Maxtor Corporation
500 McCarthy Boulevard
Milpitas, CA 95035 USA

To: T10 CAP Working Group
Contact: Mark Evans
Phone: 408-894-5310
Email: mark_evans@maxtor.com
Date: 25 August 2003

Subject: SAM-3, new Terminate Data Transfer transport protocol service and related clarification

Figure 1 — SCSI transport protocol service model for Terminate Data Transfer

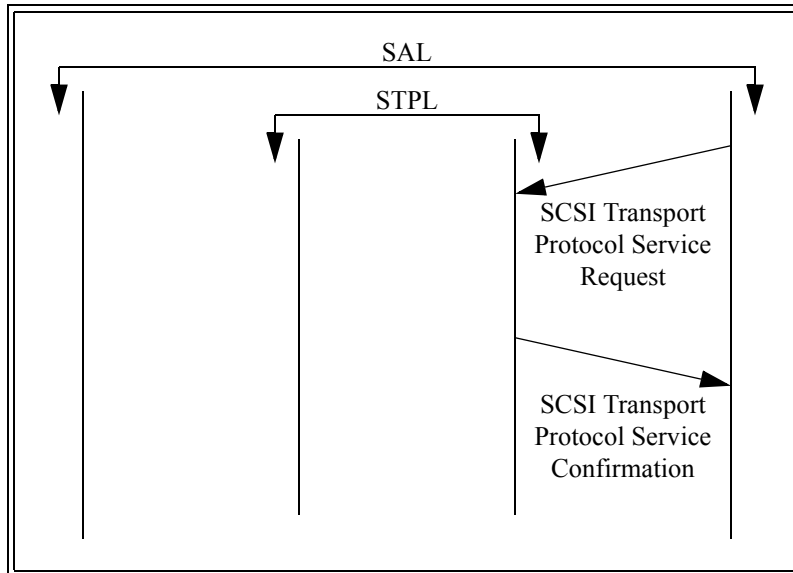
Item 1) Add the following into clause 4.15 The SCSI model for distributed communications:

When a device server invokes a Terminate Data Transfer SCSI transport protocol service, the interactions required to complete the service do not involve the SCSI Transport Protocol Service Interface or the application client. Only the STPL in the SCSI device that also contains the device server is involved. Figure 3 shows the relationships between the SCSI transport protocol service types involved in a Terminate Data Transfer request.

Figure 2 — Device server Terminate Data Transfer transaction and related STPL services

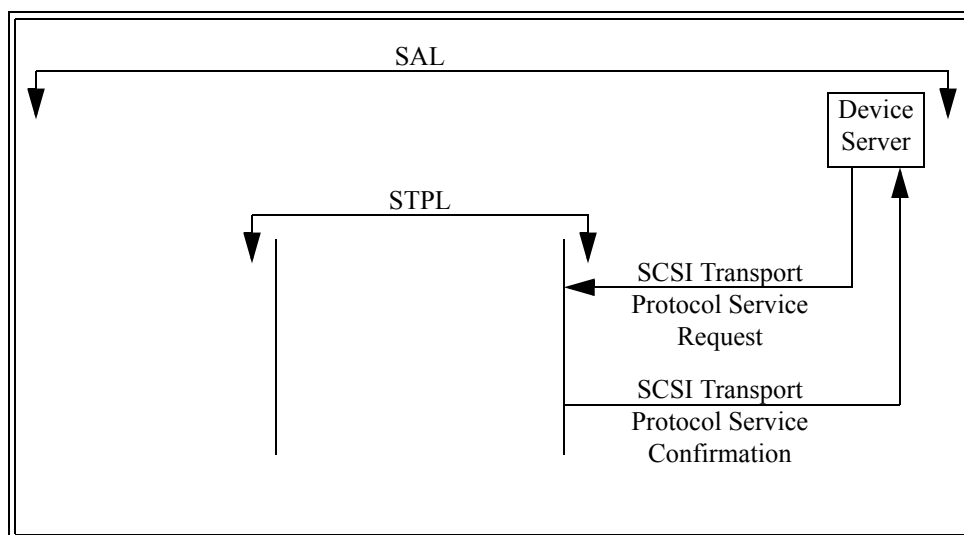
Figure 4 shows how SCSI transport protocol services may be used to process a device server Terminate Data Transfer transaction.
